SPIRE-RAL-NOT-000847

JPL SPIRE Interface Drawings

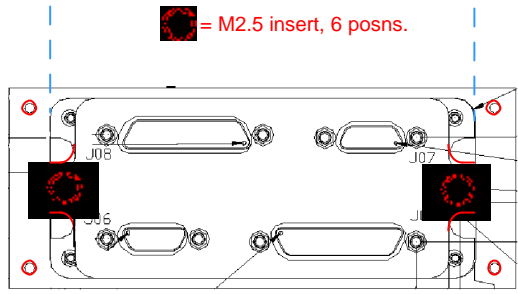
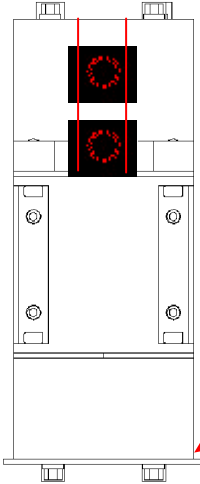
As I understand it, there are rear-bulk-head mounted plug connectors on bot ends of this unit. Please add a note that the "Walls have apertures sized such that, when assembled with worst case PCB to wall tolerances, the rims on the socket shells will be able to pass through these apertures, giving full connector mating." or some equivalent wording.

Red shows changes for M2.5 mounting.

Need small amount of extra material on rear web to stop thread insert breakout.

Blue construction lines show front face can be left unchanged, but I've made module's width downwards only to keep a 40mm rack spacing.

Rmax 0.25 typ
Rmin 0.2 typ

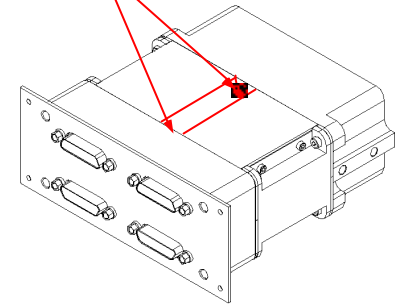
To meet spec, on distance between fasteners when holding RF seal along the unit's two dividing walls. One soln. would be to add 4 fasteners like the two shown. Please specify JPL choice.

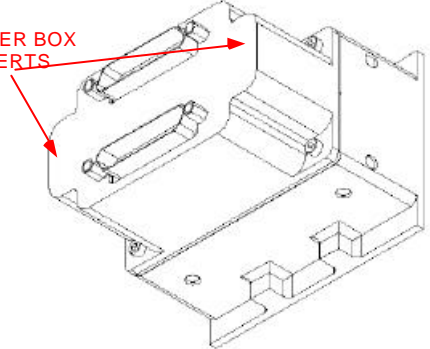
ONLY CHANGE TO FILTER BOX IS PAIR OF M2.5 INSERTS

The items in red need to be addressed. It has been clarified that if non-isometric or UNC thread inserts are used, JPL needs to supply the fasteners, shown by a note on the ICD [and tool to fit heads if non-standard]. This drawings has always shown in red that extra material will be needed to accommodate M2.5 inserts in the JFET modules. We have also discussed thread depths and positional tolerances. If only M2 can be fitted so be it...but not M1.6 please. Also specify mounting fastener tightening torques.
